APPLICATION FOR PERMISSION
UNDER SECTION 16 OF
THE TOWN PLANNING ORDINANCE
(CAP. 131)

擬議臨時公眾停車場(貨櫃車除外)及相關填土工程(為期3年)

Responses to Comments from Government Departments on Planning Application No. A/YL-PH/997 (refer to Planning Department's message of 23 May, 2025)

1.1 Ho Tin & Associates Consulting Engineers Limited (HTA) was appointed by the client to prepare a Drainage Proposal Report in compliance with the planning approval condition (e) of the Planning Application No. A/YL-PH/997 for Proposed Temporary Public Vehicle Park Excluding Container Vehicle (“the proposed development”) for a Period of 3 Years and Filling of Land in “Village Type Development” Zone at Lots 1043 (Part), 1046 S.A ss.1 RP (Part), 1046 S.A ss.1 S.A and HTL House Lot Blocks (Part) in D.D. 111 and adjoining Government Land (GL), Ha Che, Pat Heung, Yuen Long, New Territories (the ‘subject site’).

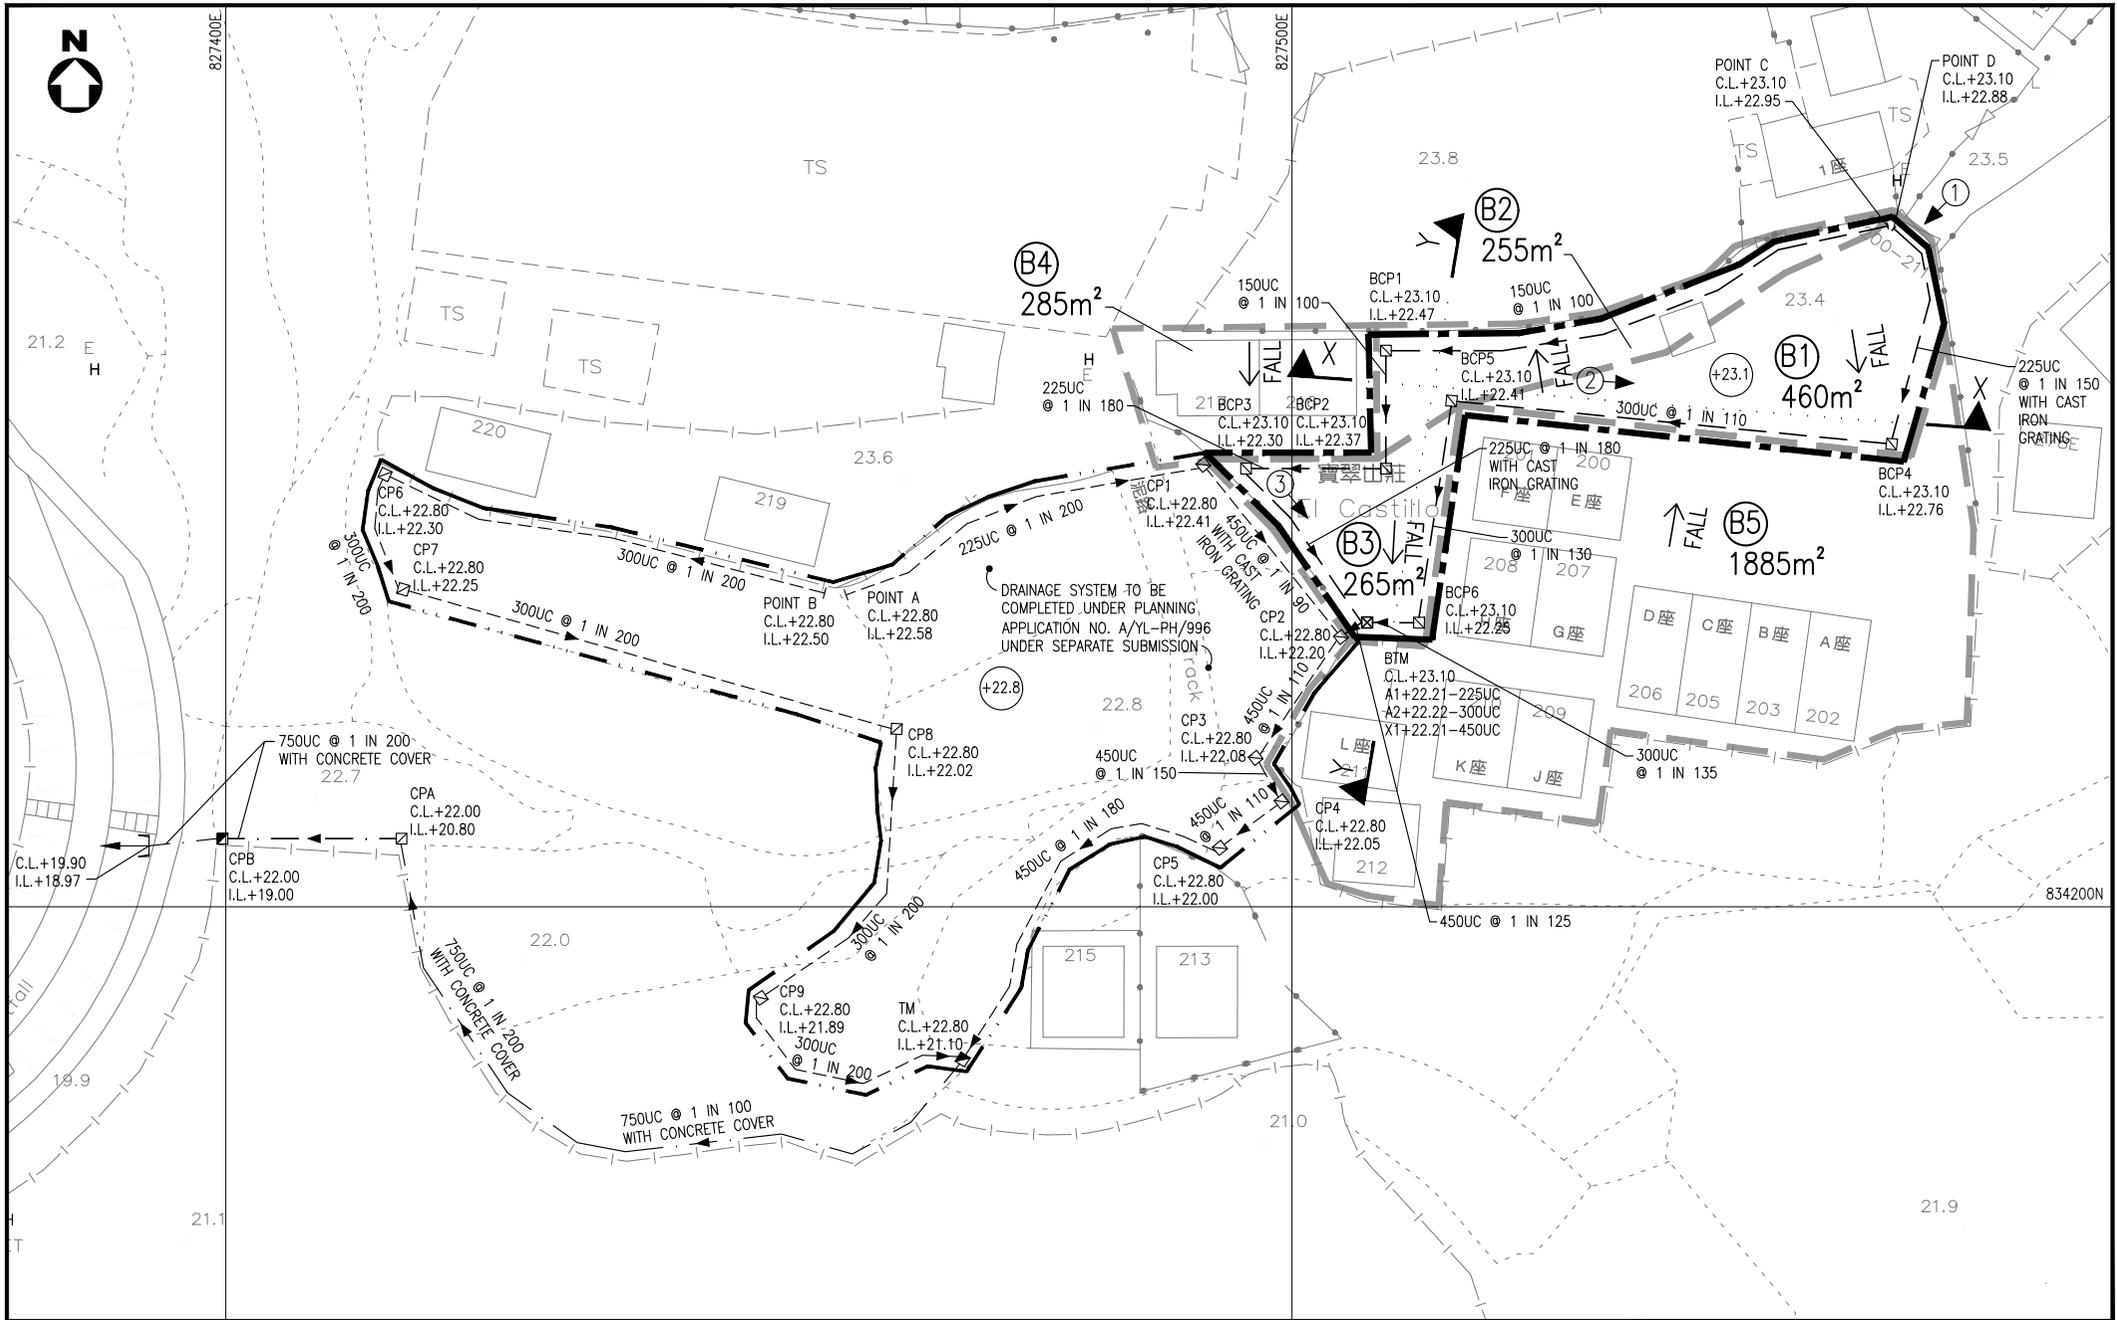
<p>(5) The standard drawings of cover slab/cast iron grating etc., for the proposed channels should be included in the submission. The Drainage Services Department's approval shall be sought for decking over channels.</p>	<p>Civil Engineering and Development Department's standard drawing of 'cover slab and cast iron grating for channels' (no. C2409J) is incorporated into this amended report.</p>

- 4.5 Proposed Stormwater Drainage Layout Plan and Site Cross Sections is shown in **Figure 2** and **3** respectively. **Details of outfall submitted and agreed under Planning Application No. A/YL-PH/996 is enclosed as Figure 4 in this report.**
